MAXIM

ERRATA SHEET

DS26518

Revision B1 Errata

Figure 1

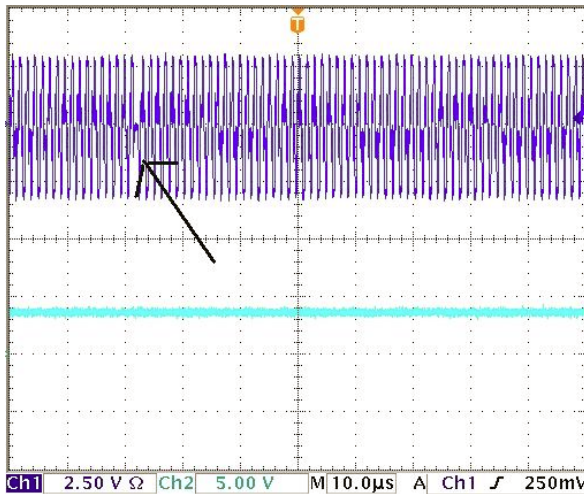
The TTIPn/TRINGn line drivers should be high impedance whenever TXENABLE is low. On rev B1 devices the TTIPn/TRINGn line drivers are briefly enabled during power-up, even if TXENABLE is low. This may cause the inactive DS26518 in a Y-cable application to attenuate the transmit waveform of the active DS26518 and create a bit error, as seen in the figures below.

None.
